STAFF RECOMMENDATION 934 McFerrin Avenue July 18, 2018

Application: New construction-infill
District: Greenwood Neighborhood Conservation Zoning Overlay
Council District: 05
Map and Parcel Number: 08208010200
Applicant: Root Arch
Project Lead: Melissa Baldock, melissa.baldock@nashville.gov

Description of Project: Application is to construct a development with six structures and twelve residential units.

A1 SITE PLAN

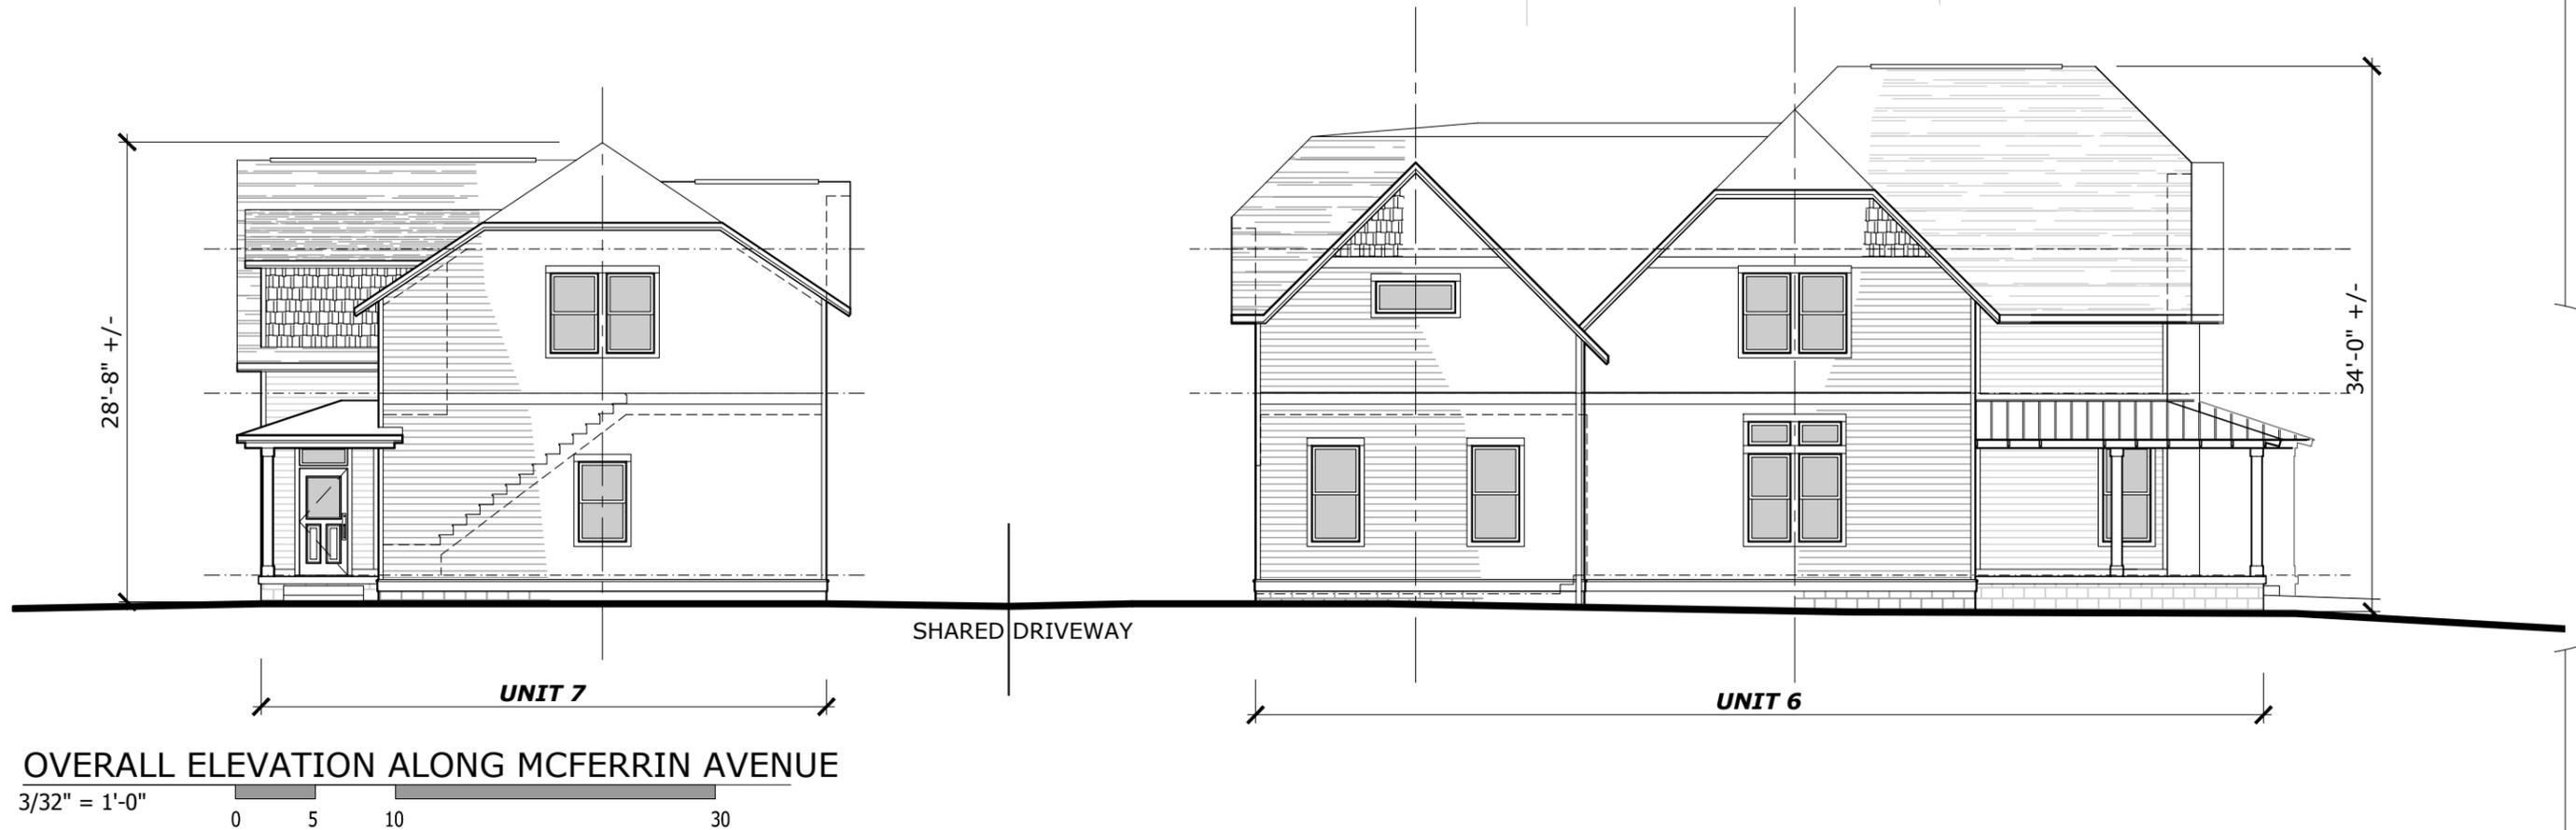
The proposed development will be largely oriented to face Seymour Avenue, which is appropriate (Figure 5). There will be three duplex structures facing Seymour Avenue. At the back, there will be three smaller structures also containing two residential units each. Vehicular access to the site will be via new curb cut and shared driveway off of McFerrin, towards the back of the lot, in between the two sets of structures. The driveway is approximately twenty-two feet (22') at the street. Typically the Commission has not allowed for driveways that exceed twelve feet (12') in width. Because of the density of the lot, staff finds the wider drive to be necessary but is concerned about its visual impact on the historic neighborhood. Each unit will have attached parking, which is not typically allowed for the front units, but staff finds it to be appropriate in this instance because of the density of the site.

The units facing Seymour Avenue have walkways leading from the front porches to the sidewalks. Unit 6, located at the corner of Seymour and McFerrin has two walkways – one leading to each street. Staff finds this to be appropriate.

At the rear of the lot, a new walkway will be added, providing access to the rear units. Of the rear units, only Unit 7 will have street frontage. For that unit, the entrance will face McFerrin Avenue, and there will be a walkway leading from the McFerrin sidewalk to the entrance. Staff finds this to be appropriate.

The front setbacks of the houses facing Seymour are proposed to be twenty-nine feet (29'). This is forward of the neighboring house at 846 Seymour Avenue. However, since 846 Seymour Avenue and the other houses on the 800 block of Seymour Avenue are all non-contributing, staff finds the proposed front setback to be appropriate. The units will be a minimum of five feet (5') from the interior property line and twenty feet (20') from the rear property line.

Along McFerrin Avenue, the new structures will be a minimum of thirteen feet (13') from the McFerrin side property line. Staff finds this side setback to be appropriate. Neither McFerrin nor Seymour Avenues currently have sidewalks. The applicant has been approved by the Board of Zoning Appeals (BZA) for a five foot (5') side walk and four foot (4') grass strip along both McFerrin Avenue and Seymour Avenues.

The units facing Seymour Avenue are largely spaced ten feet (10') apart. However, at the rear, the units widen and the structures are just six feet (6') apart. The reason for the extra width at the rear is that the rear attached garages need a minimum width of forty feet (40') for four cars. For Units 1, 2, 3, and 4, the rear bump outs are two-stories in height, whereas the main form of these units is one-and-a-half stories. Staff recommends that for these units, the extra width be only one story in order to keep the overall scale appropriate for the context and provide more spacing between the residential units. For Units 5 and 6, the main form of the house is two stories, and staff therefor finds the two-story form is appropriate for the extra width.

The applicant is proposing a minimum of twenty-six feet, ten inches (26'10") in between the houses facing Seymour Avenue and those at the rear. Staff finds that this distance is greater than what is typically required for spacing between primary structures and outbuildings. Staff finds that the spacing between the front and the rear units meets the design guidelines. Likewise, staff finds that the spacing between the side walls of the

Appurtenances & Utilities: The site plan does not indicate the proposed location of the HVAC units and other utilities. All HVAC units and utilities should be located in a minimally visible location at the rear of the structures, or on the side facades, beyond the midpoint of the structures.

With the conditions that the rear, wider portions of Units 1, 2, 3, and 4 be one story in height; and Units 3 and 4 have a continuous front porch floor, staff finds that the proposed development meets Sections II.B.1.c. (Setback and Rhythm of Spacing), II.B.1.f. (Orientation), and II.B.1.k. (Multi-unit Detached Developments/ Cottage Developments) of the design guidelines.

SEYMOUR AVENUE ELEVATION - UNITS 3-4

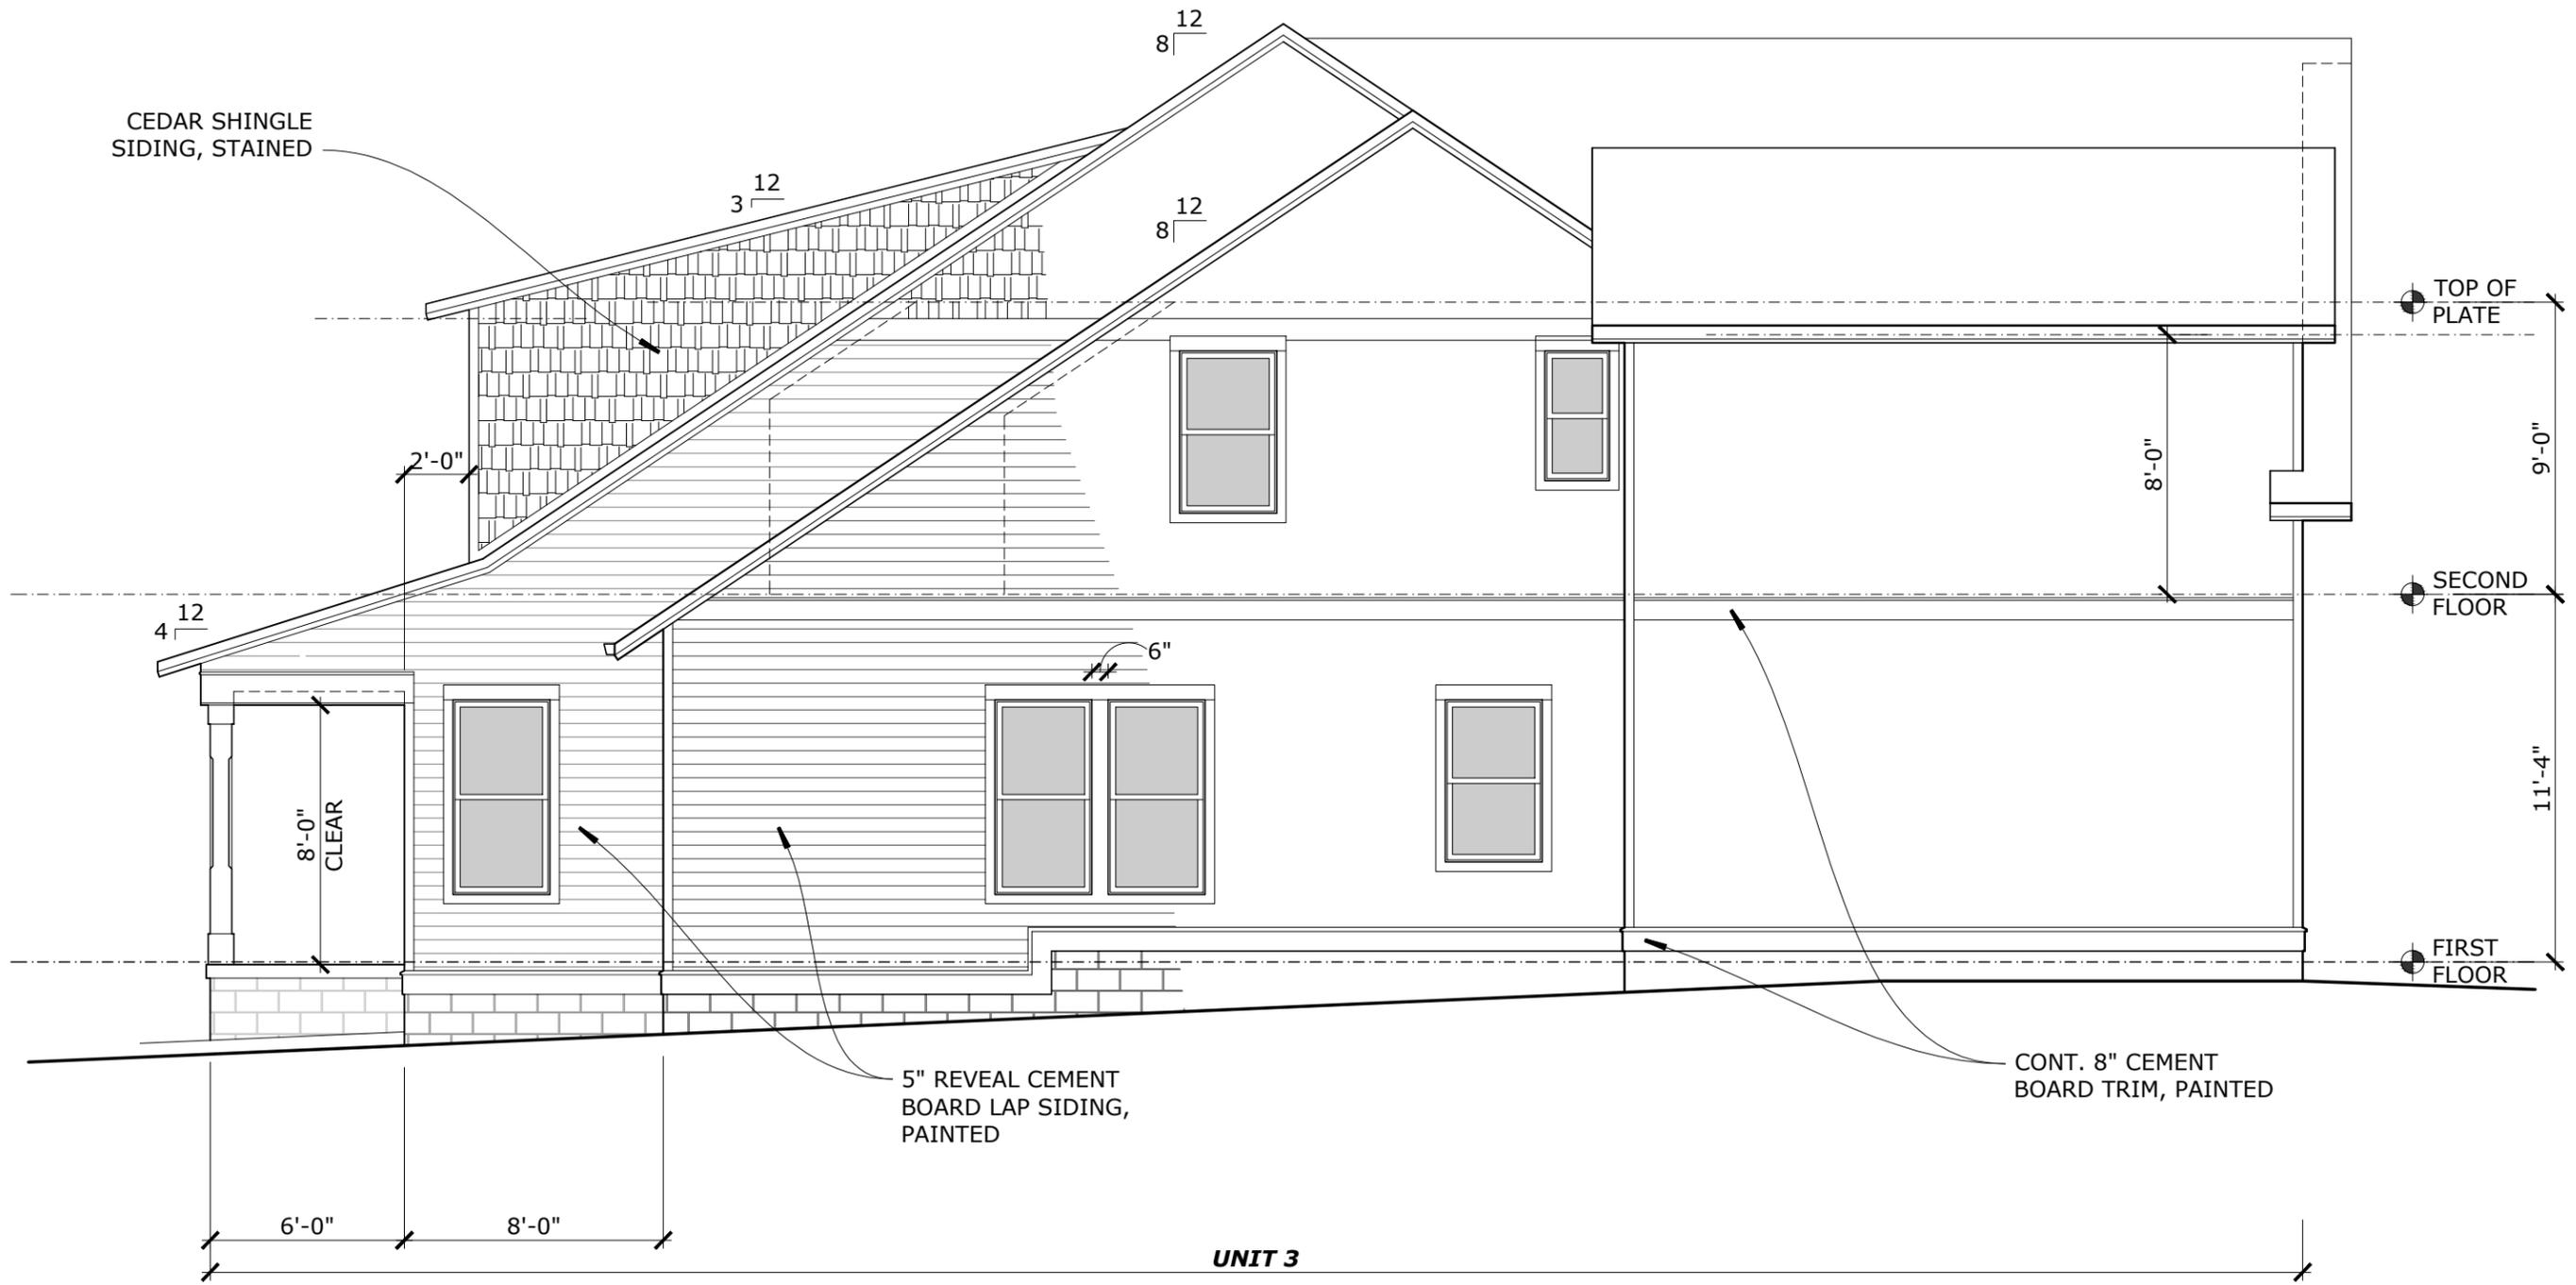
The units facing Seymour Avenue all have front porches that are a minimum of six feet (6') deep. Units 3 and 4 share the same porch roof, but have porch floors that are separated by two feet, eight inches (2'8"). (This is not evident on the floorplan but is on the front elevation.) In looking at historic duplexes, typically, either the porches shared the same floor and the same roof or the porch roofs and the porch floors were entirely separate. Staff finds that the separate porch floors under the continuous porch roof increase the perceived width of the houses and are not appropriate. Staff recommends that Units 3 and 4 have a continuous porch floor or separate porch roof forms.

*The front façade drawing shows a front door that is 1/4 glass for Units 3 and 4. The design guidelines state that, “*Generally front doors should be 1/2 to full-light.*” Staff recommends that all front doors be at least half-glass.
